Proposed changes to the England Coast Path at Saunton Down, Down End, Croyde

Natural England's Variation Report to the Secretary of State

Coastal Access Variation Report VR11
March 2022

Map VR11 - Variation 1 - Saunton Down, Down End, Croyde

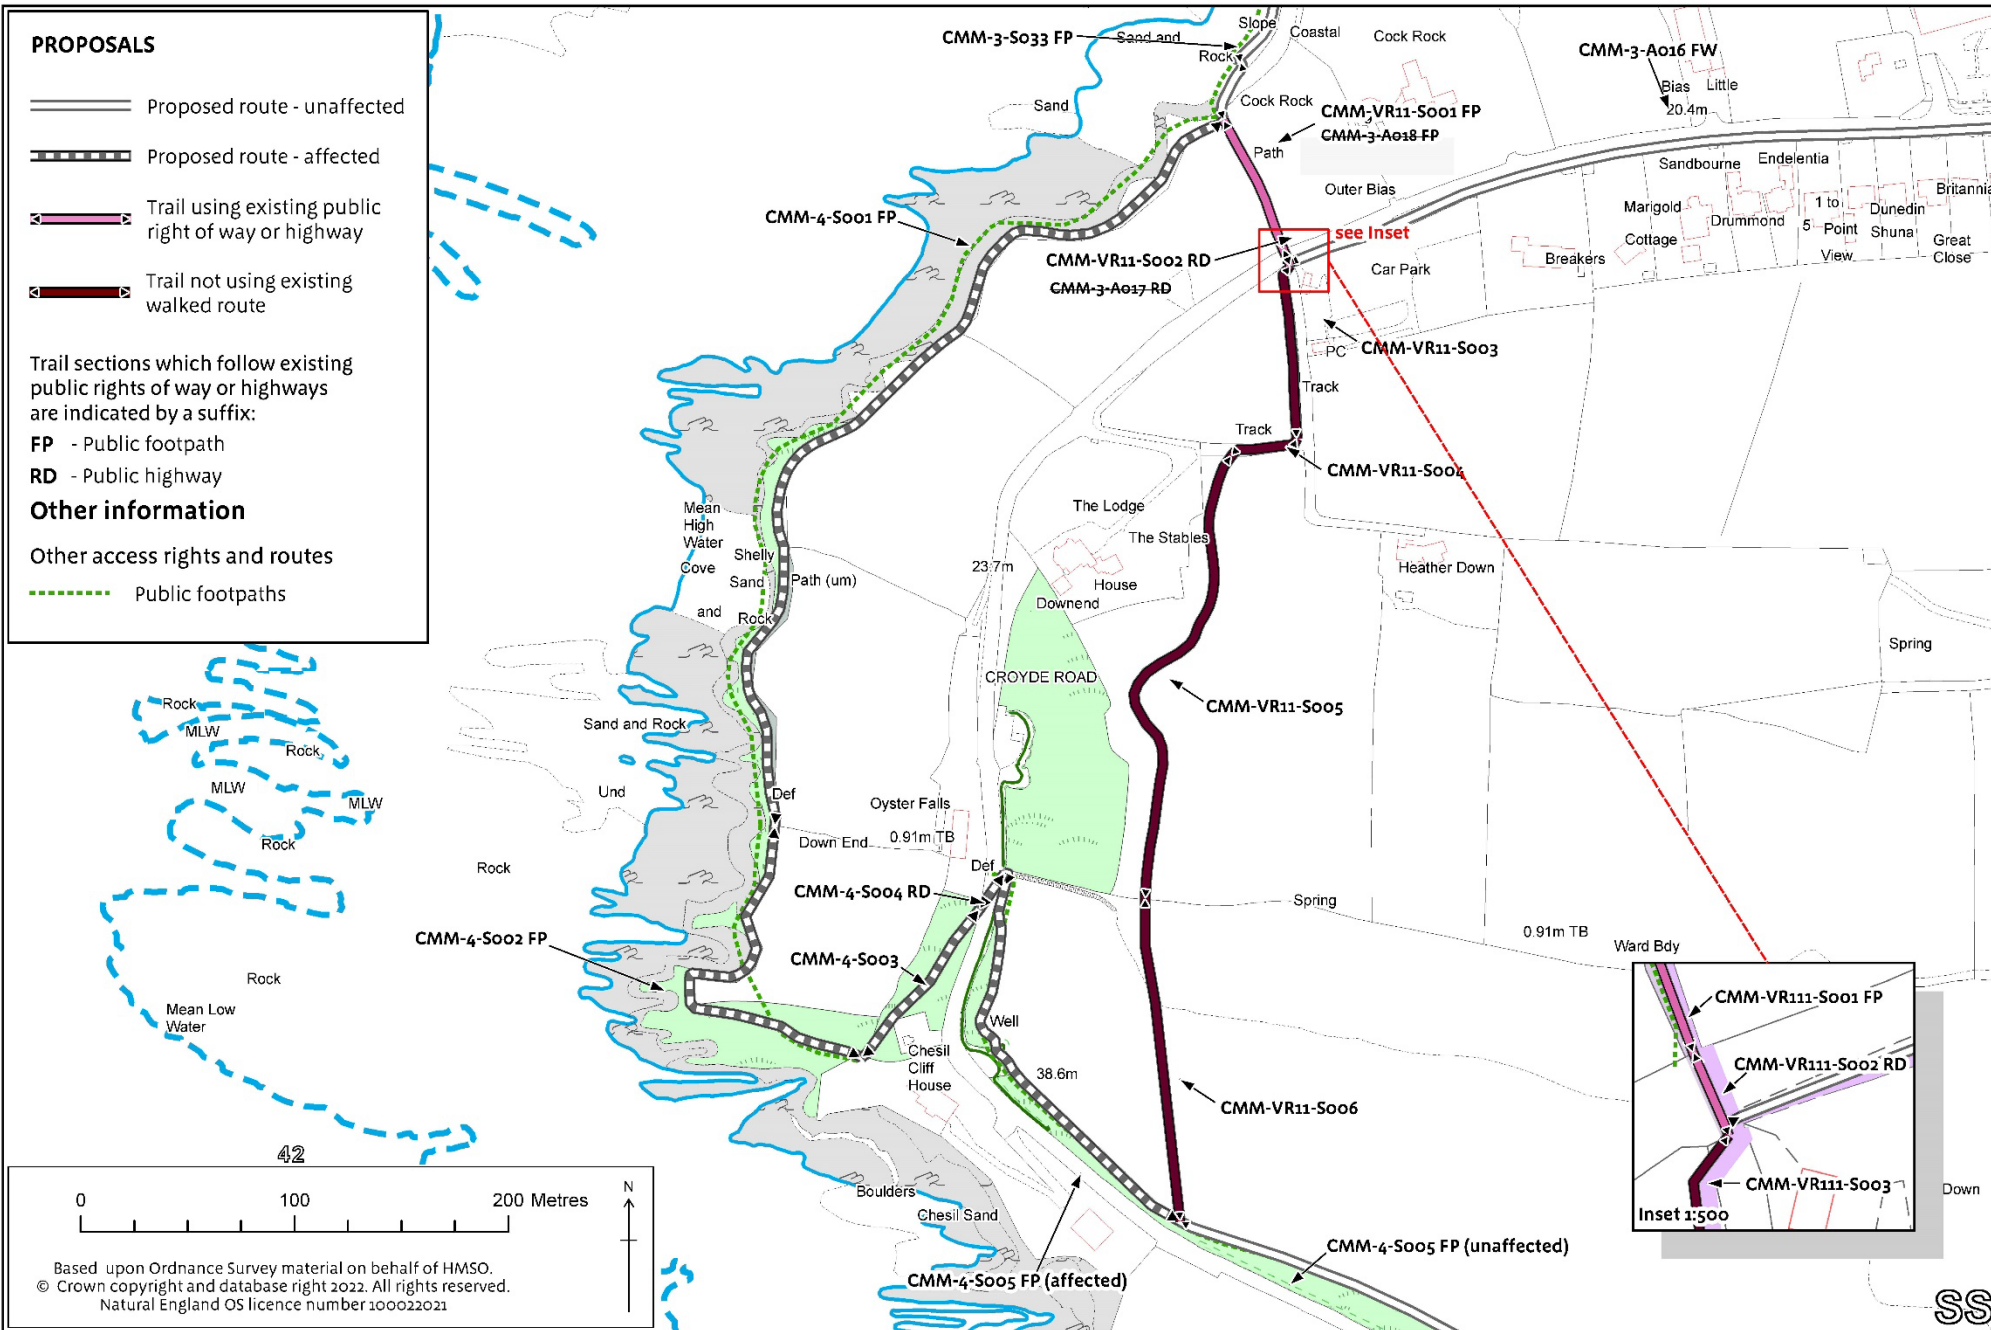
2.1.1 Following discussions with the owners of Oyster Falls and Down End Car Park, a new route avoiding the hazardous road crossing between Chesil Cliff House and Oyster Falls, has been proposed. In addition, this new route provides spectacular high level views to the north (over Croyde beach towards Baggy Point), to the west (Lundy Island, on a clear day) and to the south west (as far as Hartland Point).

followed the existing South West Coast Path (SWCP), a public footpath, from Down End Beach, up concrete steps and then along the seaward edge of fields to the promontory below Chesil Cliff House, up towards the old Coastguard Lookout and then diagonally up the slope towards the property known as Oyster Falls before crossing the road and rejoining the existing SWCP above Oyster Falls and on to Saunton.

2.1.3 The proposed variation would remove the originally proposed trail sections CMM-4-S001 to CMM-4-S005 (part) from the trail but they would still be accessible to walkers as they are a public right of way. Trail sections CMM-3-A017 RD and CMM-3-A018 FP currently form part of the alternative route on the approved trail. These would become part of the main route, becoming trail sections CMM-VR11-S001 FP and CMM-VR11-S002 RD. The ECP would then follow a new path over Saunton Down, joining up with trail section CMM-4-S005 at Chesil Cliff. (See Map VR11 – Route over Saunton Down, Down End, Croyde).

- Will increase the overall cost but will provide a much safer road crossing to the benefit of coast path walkers and visitors to Down End Beach.
- Extends for a length of 540 metres at a maximum of 190 metres eastward/inland of the original route proposed (see map VR11 Route over Saunton Down, Down End, Croyde).

- Follows the existing public footpath from the top of the steps up from the beach at Down End, along trail section CMM-VR11-S001 (previously trail section CMM-3-A018, part of the approved alternative route), crossing the Croyde to Saunton road at trail section CMM-VR11-S002 (previously trail section CMM-3-A017 RD, part of the approved alternative route), and then on grass adjacent to the track up to Heather Down (trail section CMM-VR11-S003), passing through an existing field gate and onto an old track (trail section CMM-VR11-S004) before passing through a newly created gap in the hedge bank and onto the gorse/scrub slopes of Croyde Down between Heather Down and Downend House (trail section CMM-VR11-S005).

- Will be screened from Down End House by the existing dense gorse scrub. At the top of Saunton Down the route then heads down the gorse covered slopes (trail section CMM-

VR11-S006) before re-joining the existing South West Coast Path about 100 metres east of Chesil Cliff House part way along existing trail section CMM-4-S005.
